# DEVELOPMENT REVIEW BOARD REPORT

ITEM NO. 8

SUBJECT **Wildcat Hill  
8-PP-2005**

REQUEST Request to approve a Preliminary Plat with amended development standards for a 76-lot custom home subdivision on a 360-acre parcel.

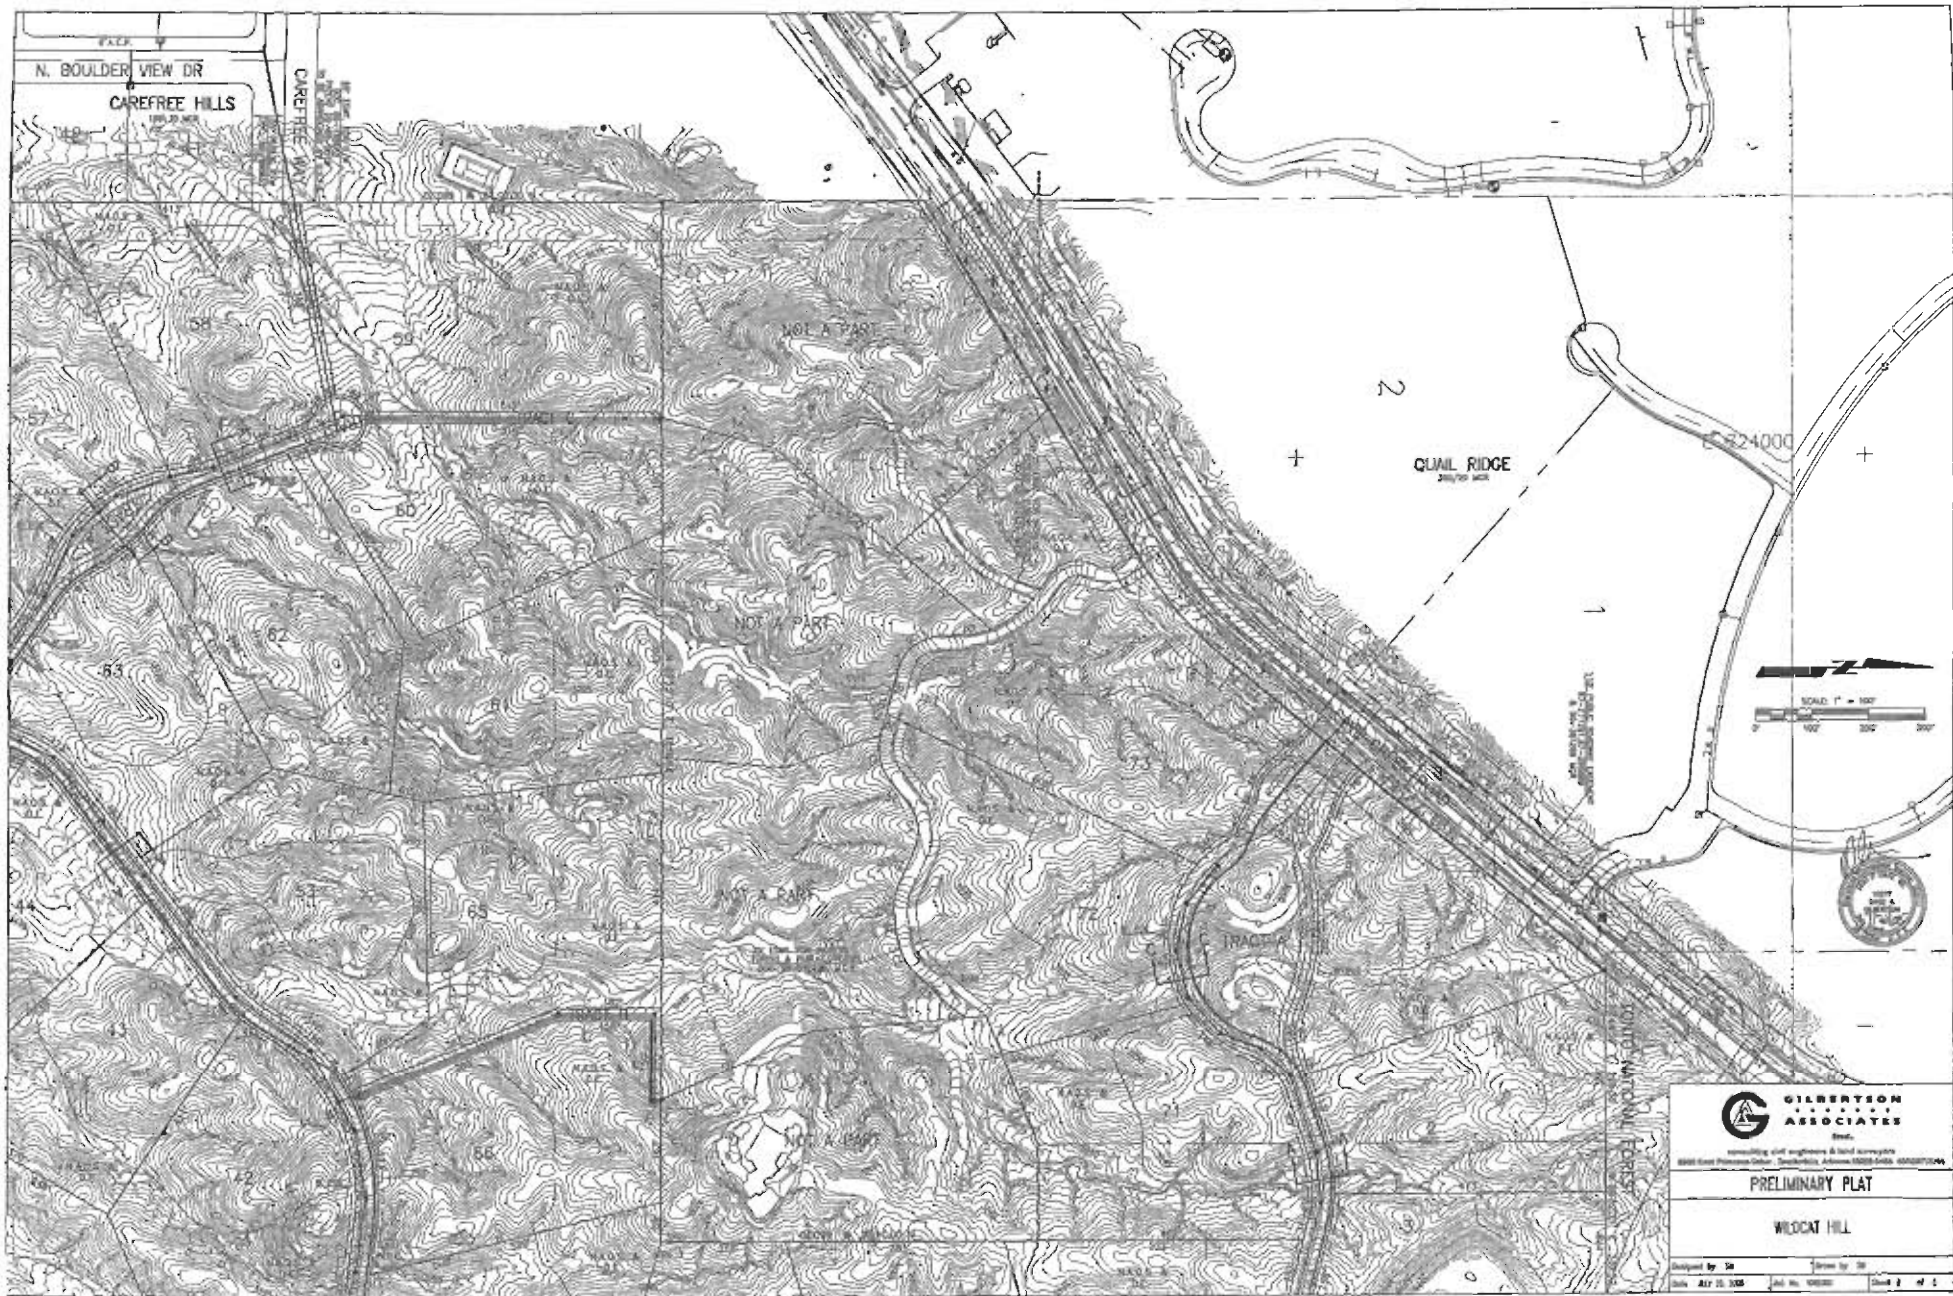
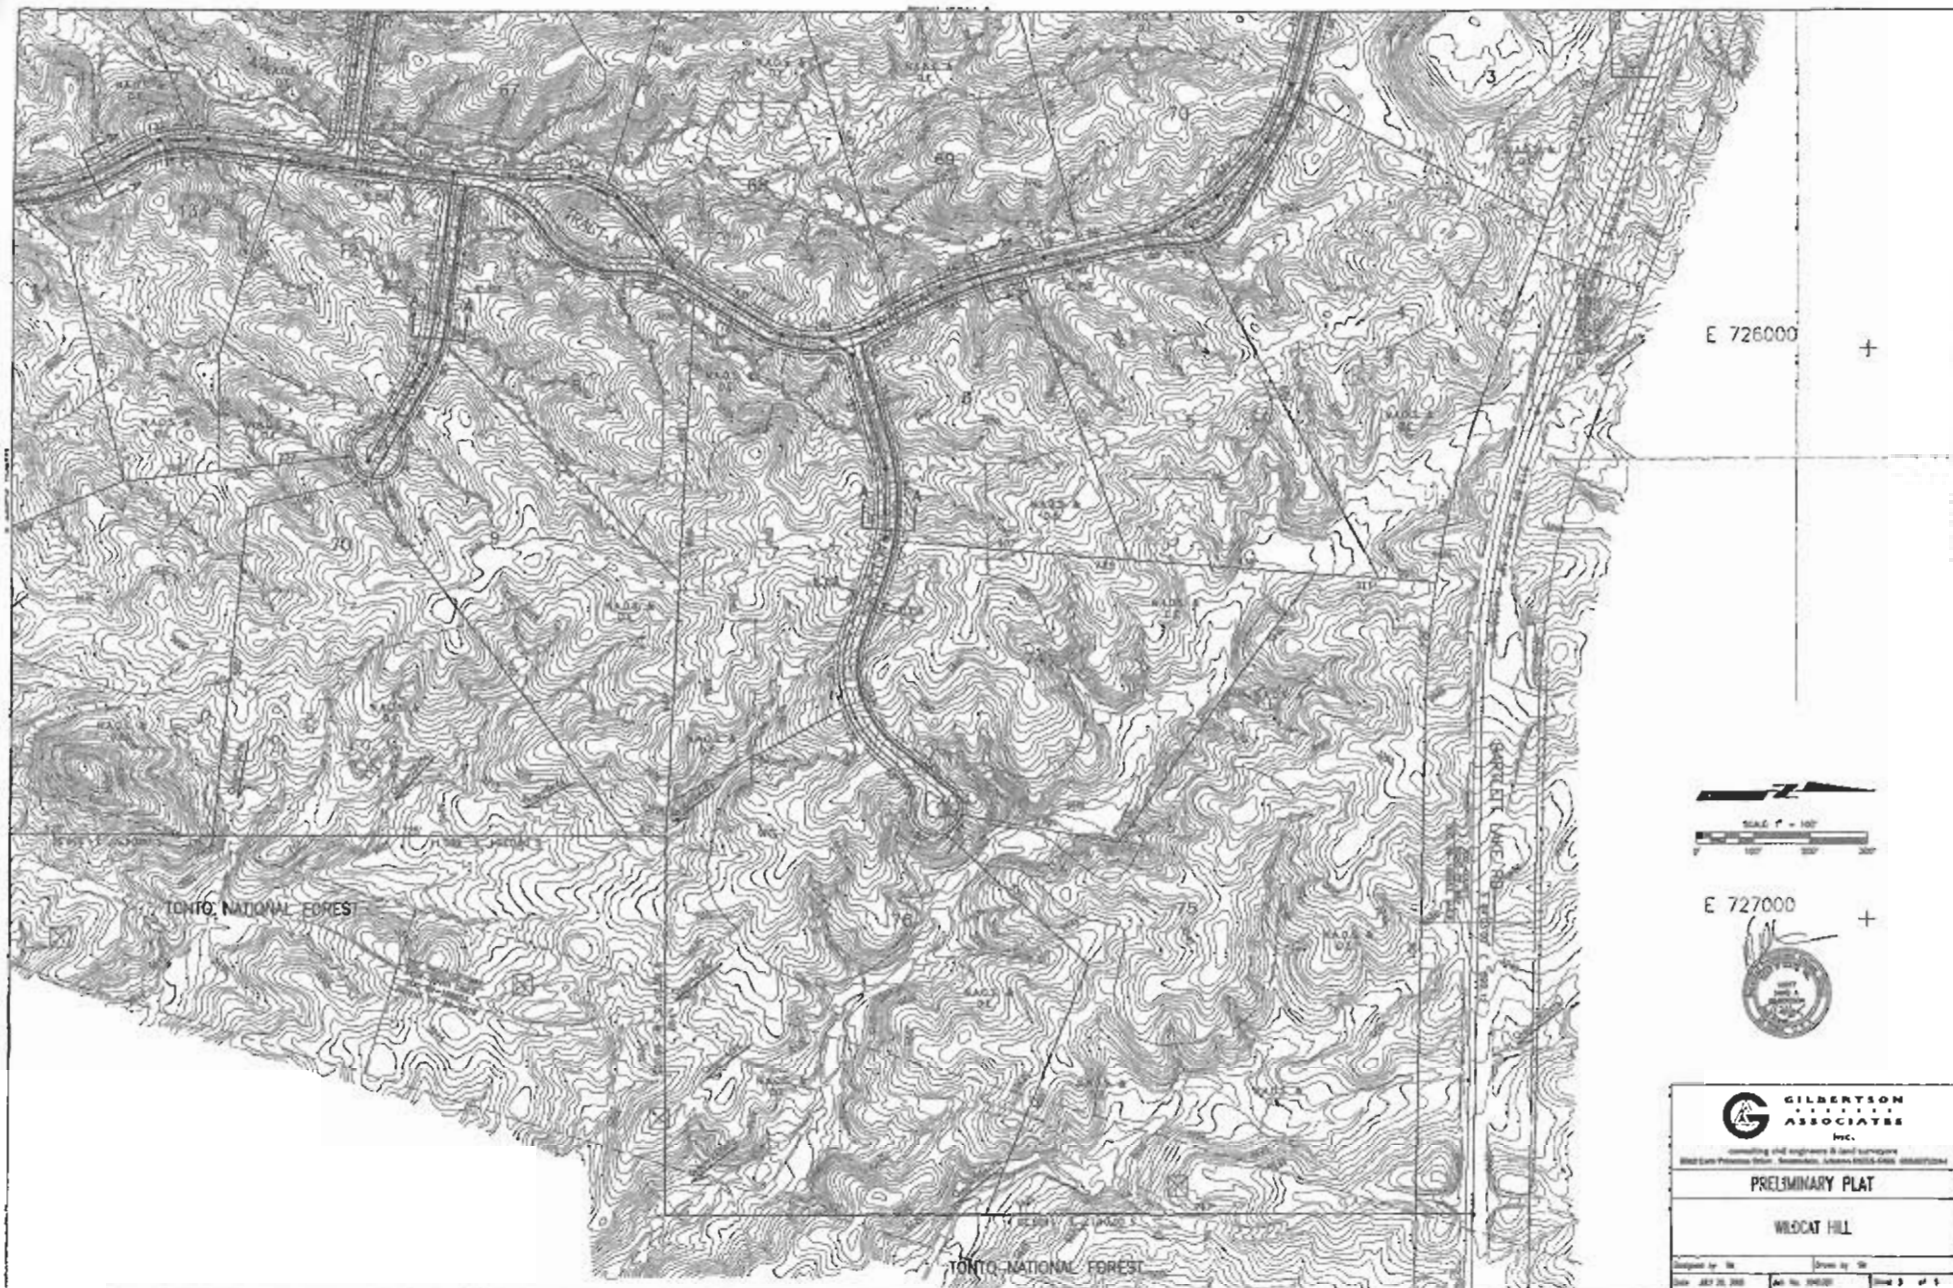
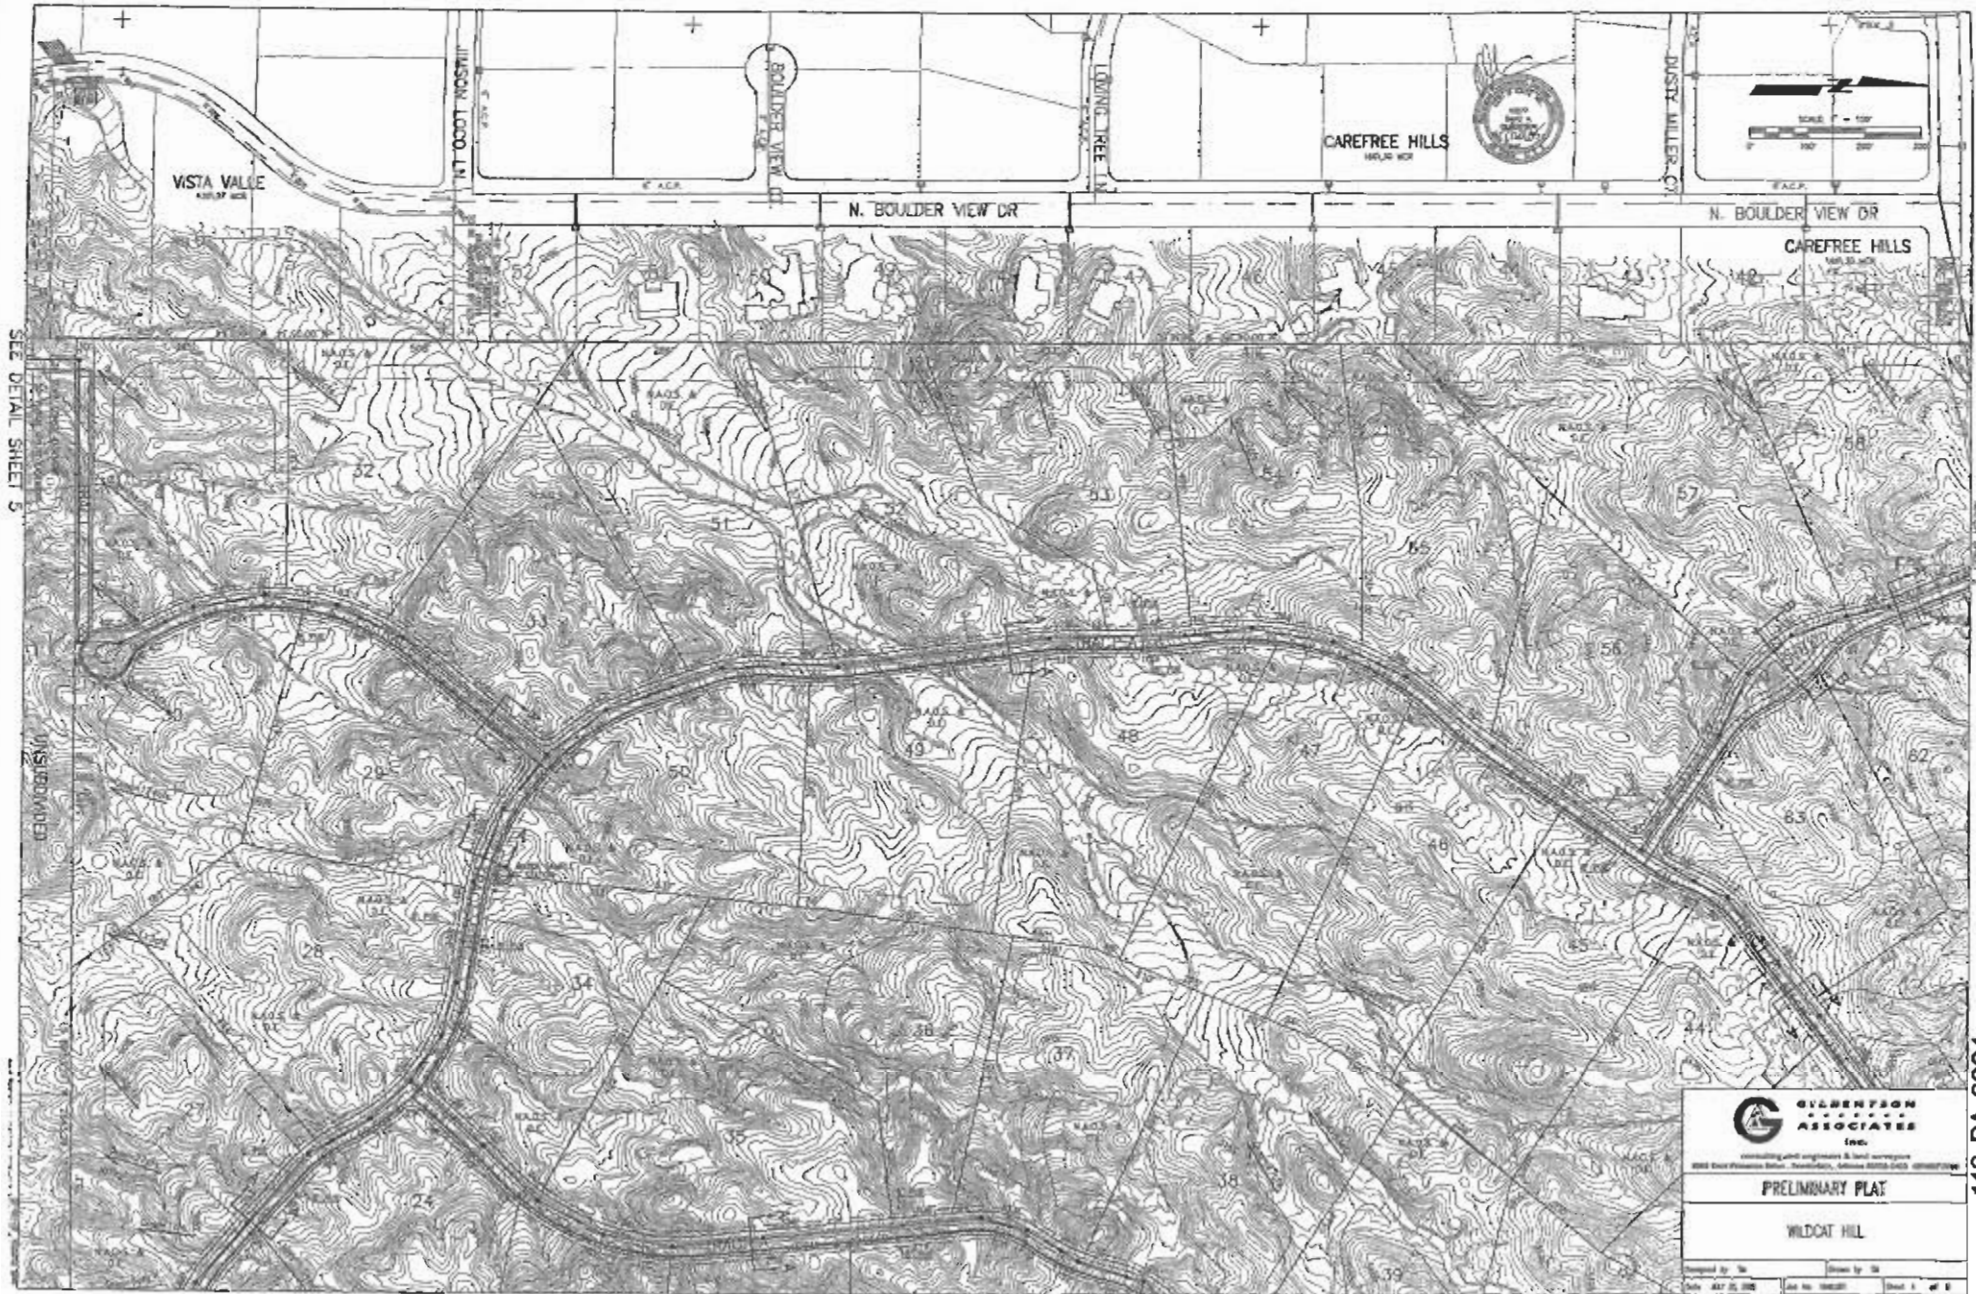
12. For the subdivision entry design, the ingress and egress lanes shall be placed closer to each other.
13. Provide emergency access connection at Carefree Highway between lots 58 and 59.
14. Exception lots (not part of this subdivision) shall have right-of-way or private street tract frontage. The developer shall provide such access and shall include this with the final plat of this subdivision.
15. The developer shall construct and dedicate a turn-around at end of the exception lots access. The access to these lots shall be 20 feet minimum width.
16. For lot driveways over 200 feet need turn around area on lot. For driveways over 300 feet need passing area on driveway for fire truck. See Fire staff for more information.

66. Where a gated entrance is proposed, the developer shall design and construct the gated entrance in conformance with Figure 8.1-1 of the City's Design Standards and Policies Manual. The entry design should make ingress and egress lanes closer than shown in preliminary plans submitted to the City of Scottsdale.
